City of Cambridge

RE: File No. 11239 – Rindge Commons Pre-K Interior Fit-Out - Addendum No. 1

Rindge Commons Pre-K

A8.2

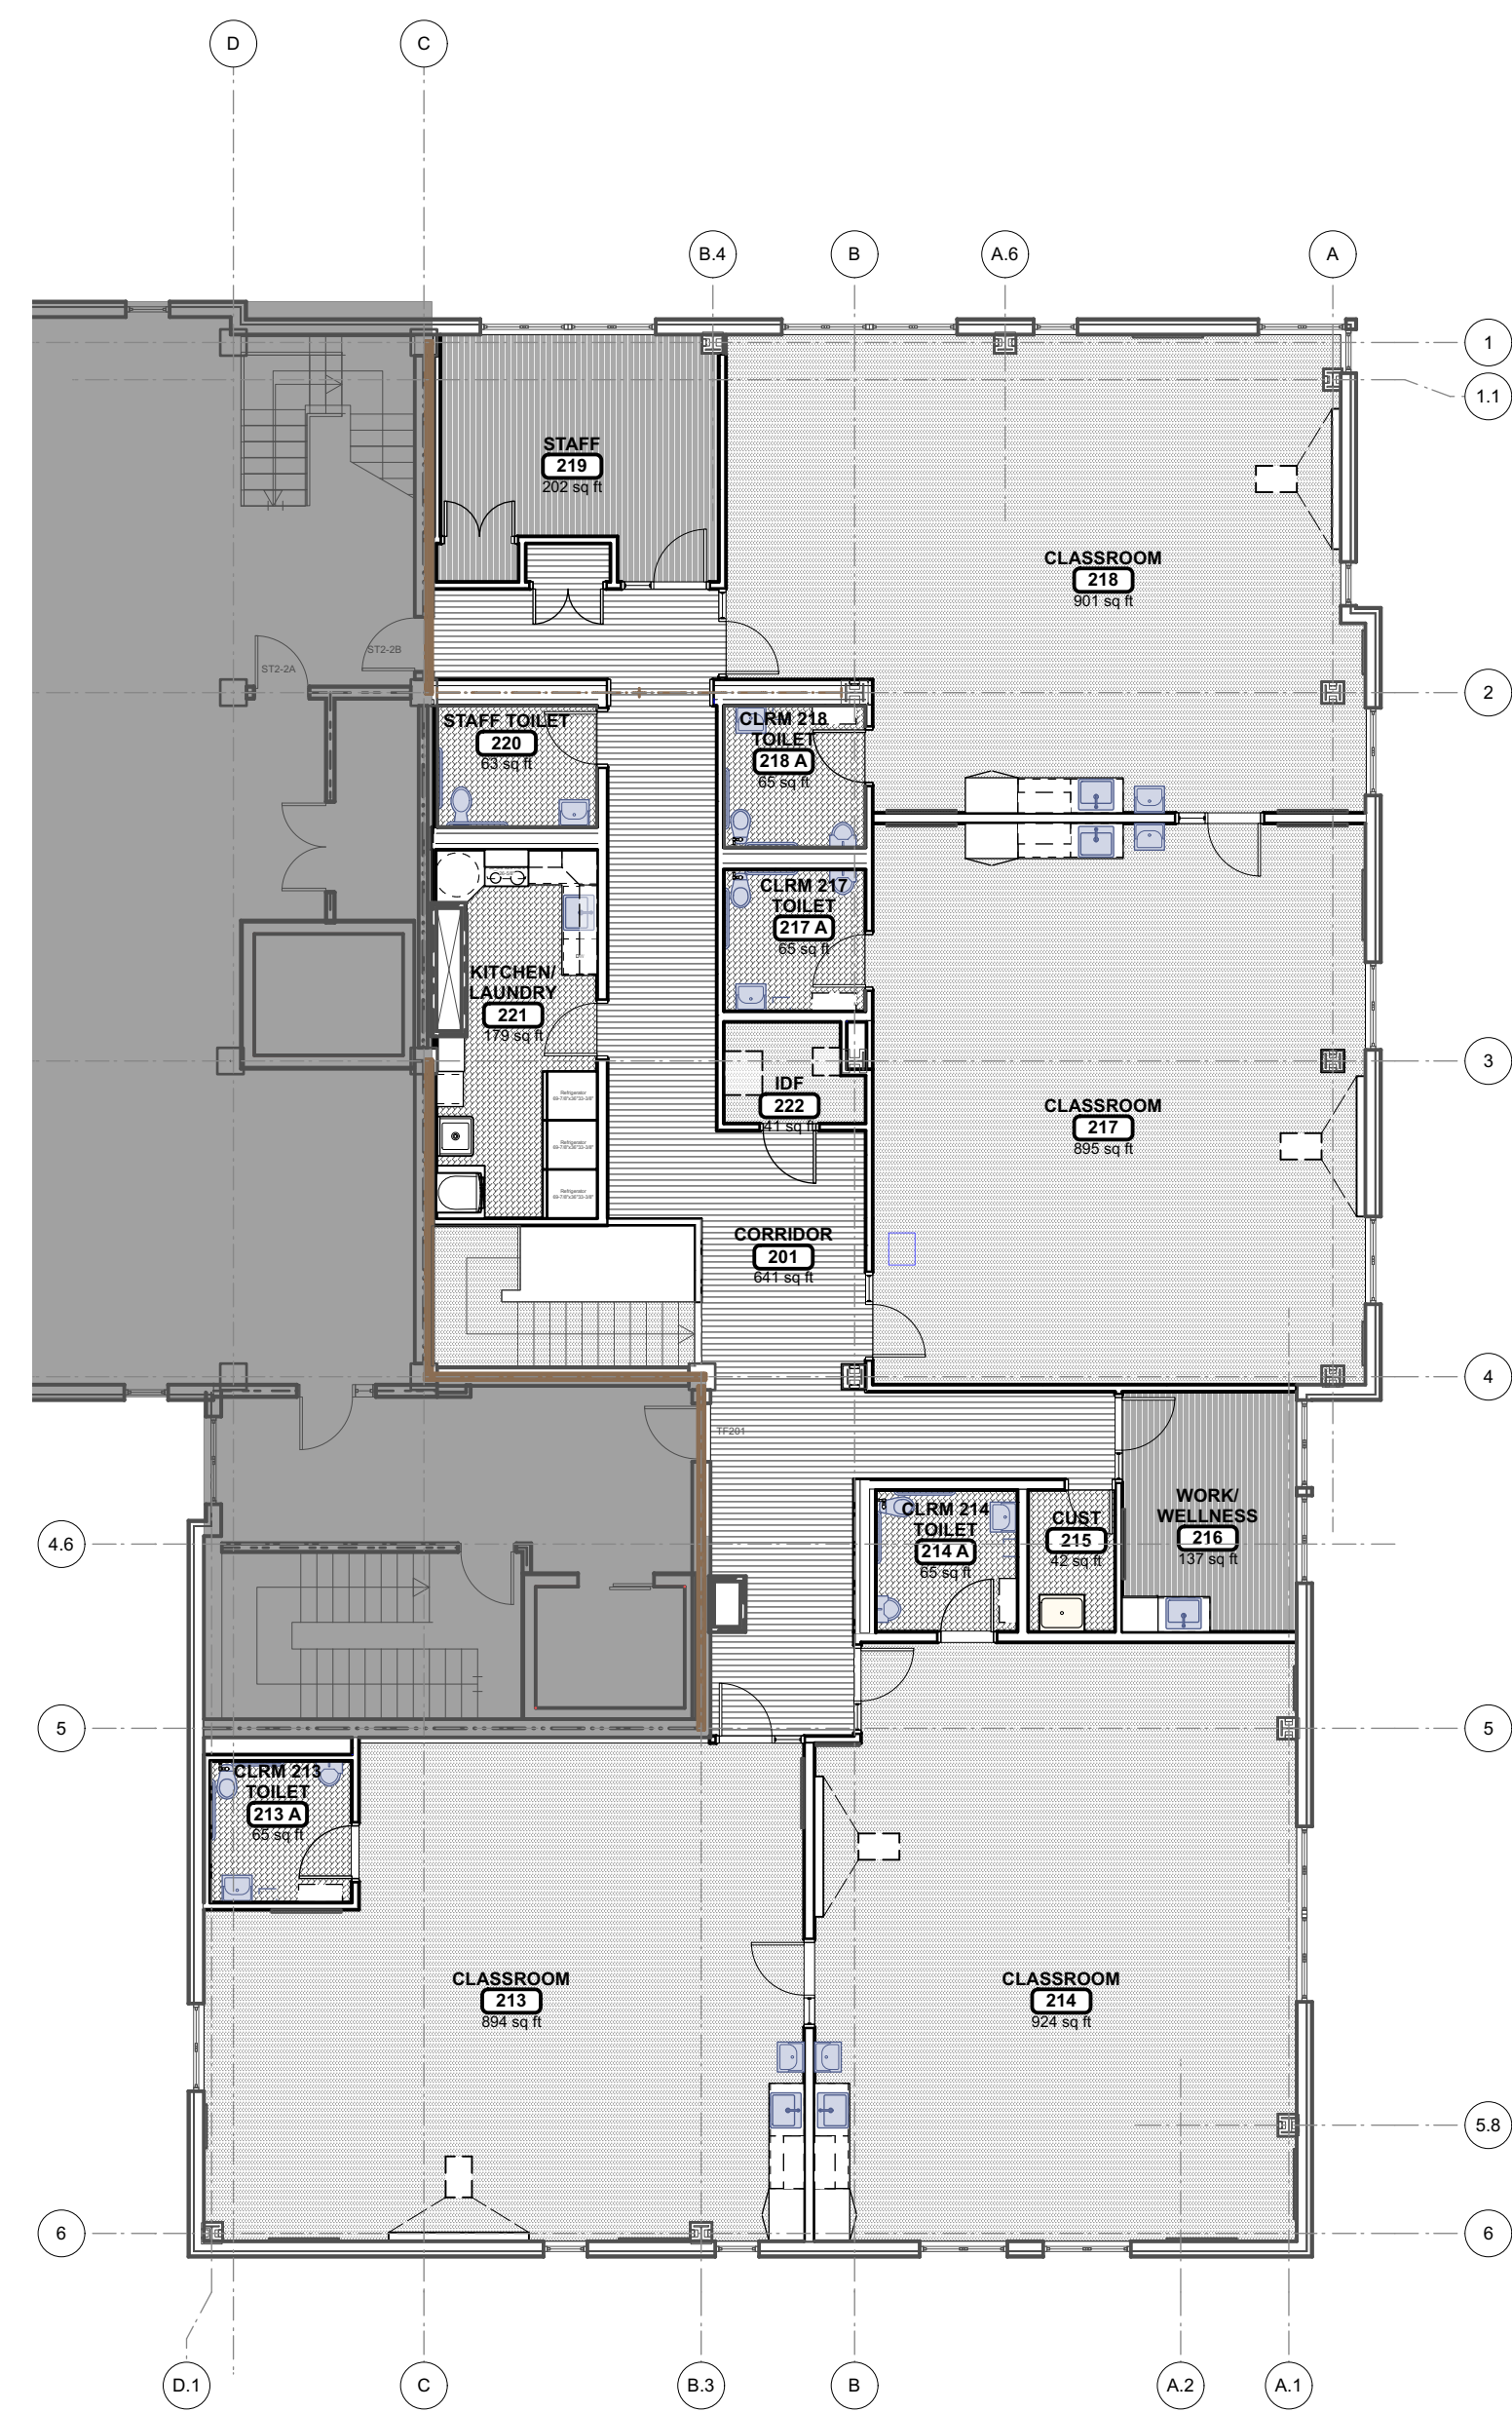
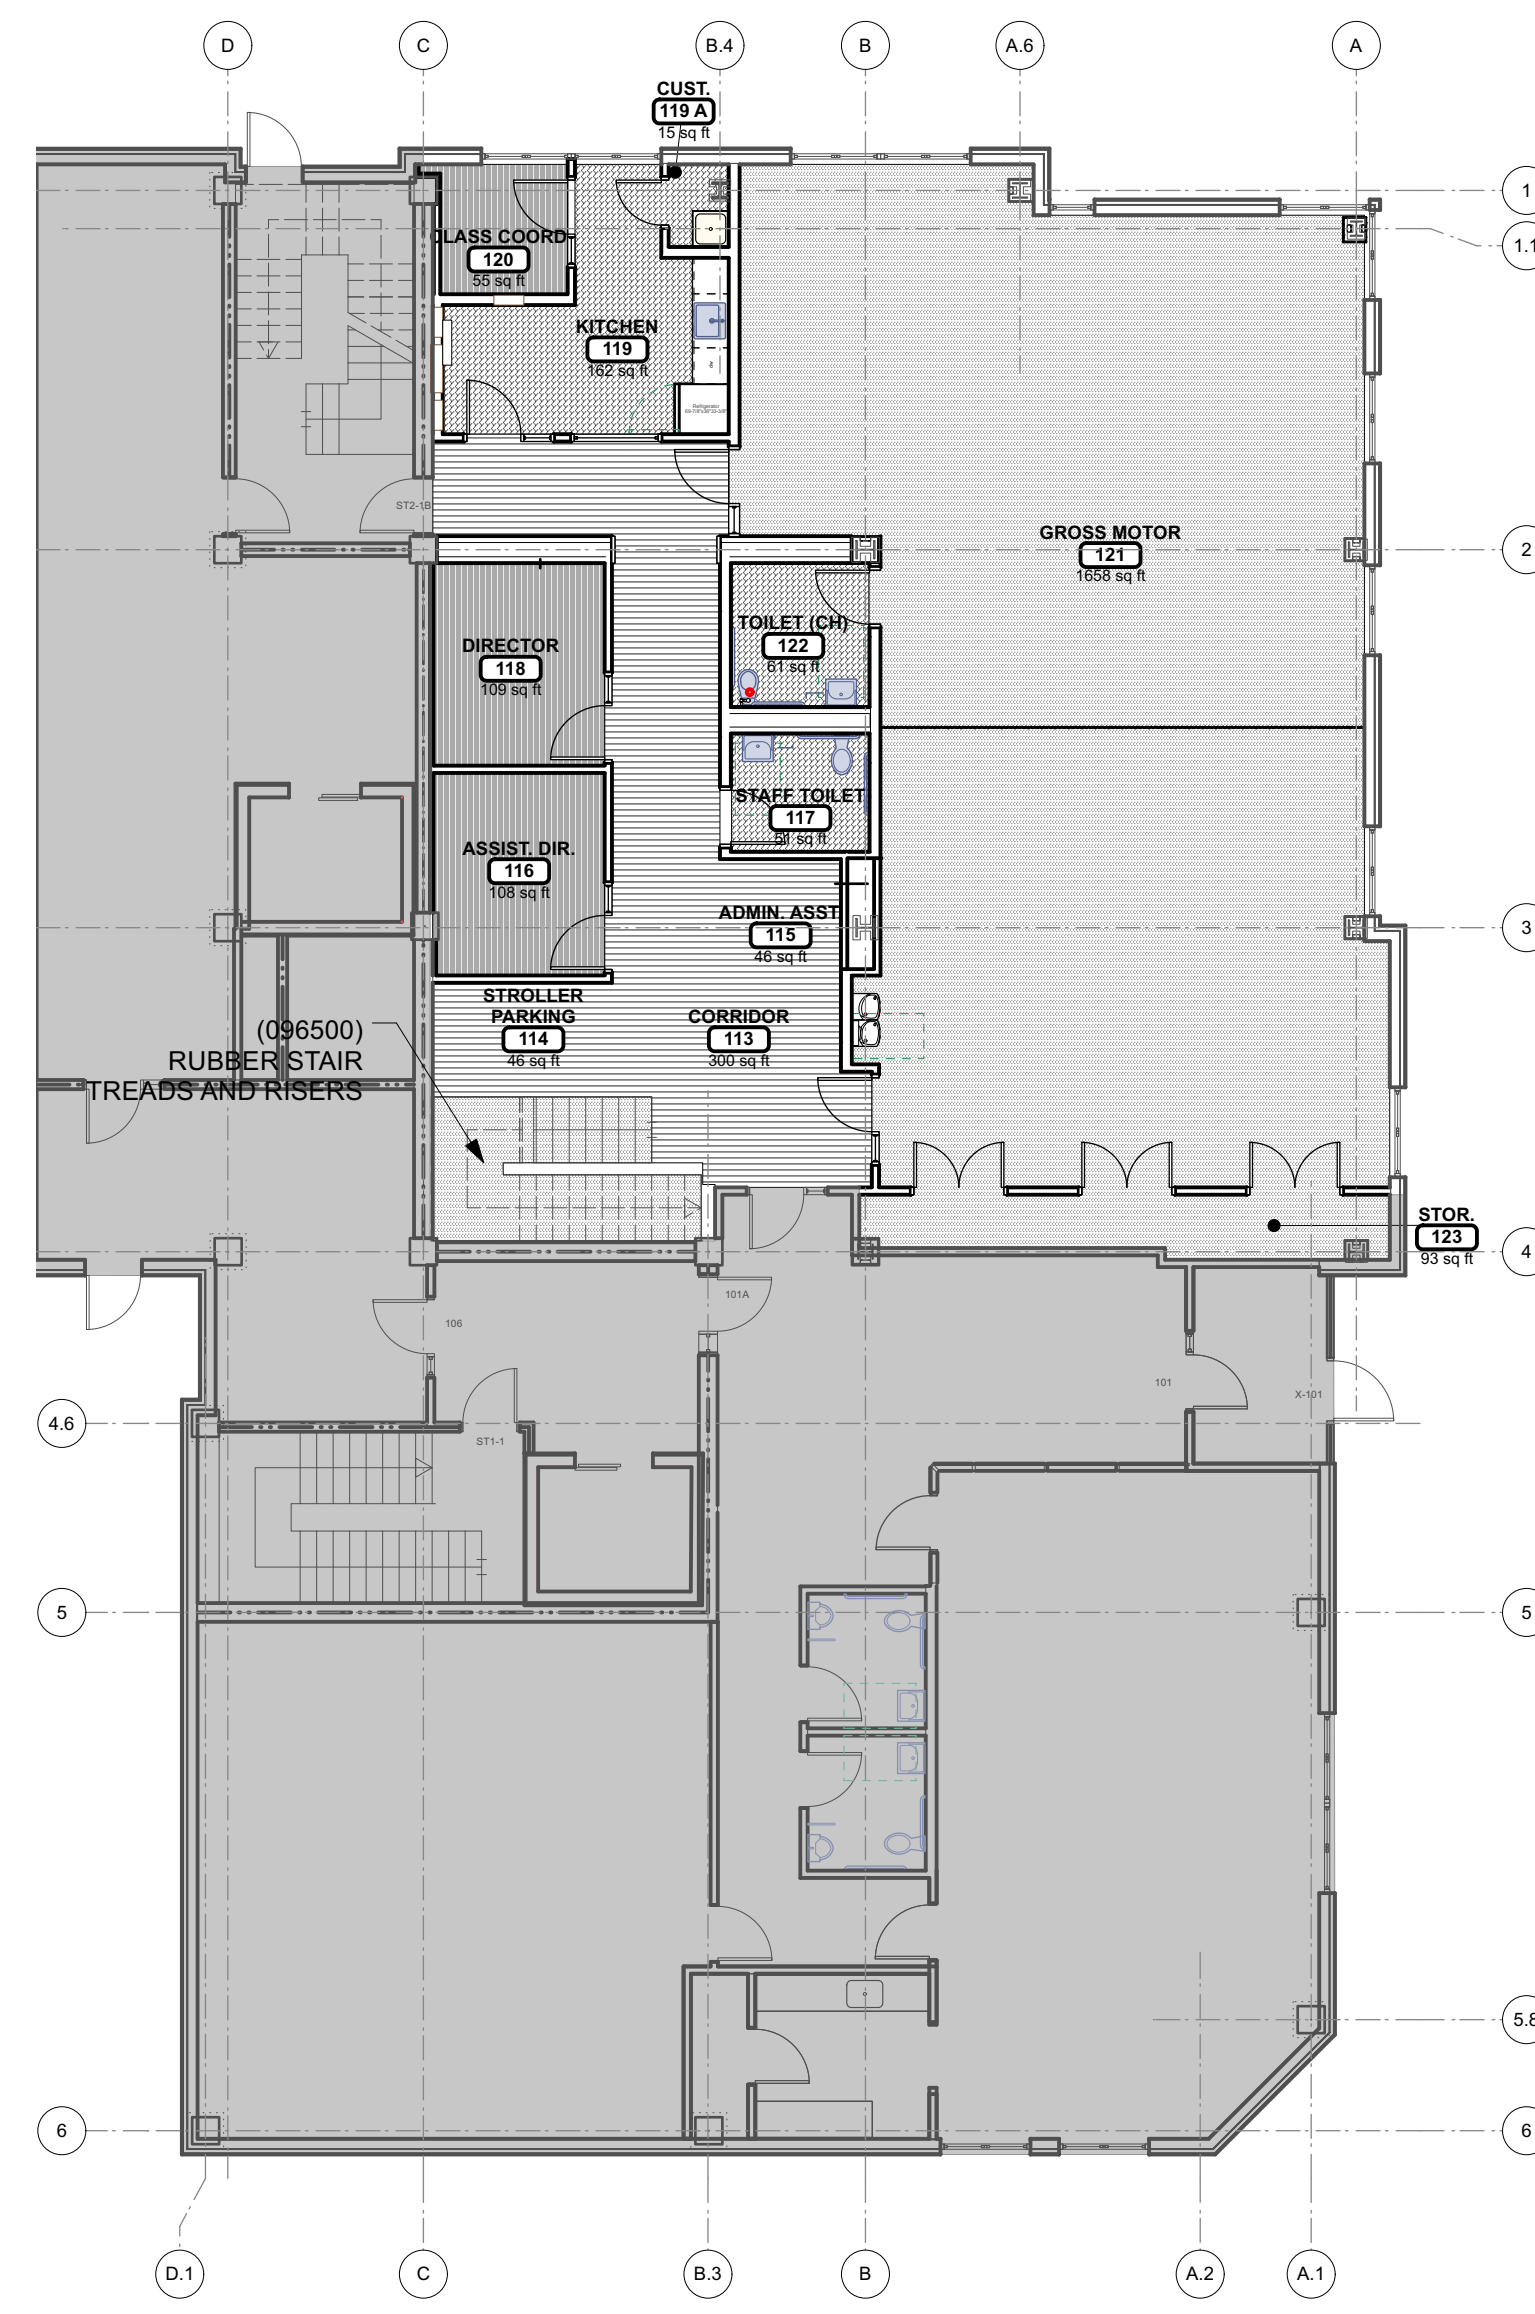
Question 1.: Room Finish Schedule on Drawing A8 has ACT material the ceiling finish in all rooms noted. Please confirm there is no painting required on any overhead ceiling surface per this finish schedule.

Question 2.: If Overhead Ceiling Surfaces are to be painted, can you confirm if all overhead surfaces are to be same color/finish.

Answer: Gross Motor Room 121 has a painted GWB ceiling. Sheet A8.2 is updated as part of this Addendum.

Answer: Gross Motor Room 121 has a painted GWB ceiling. Sheet A8.2 is updated as part of this Addendum.
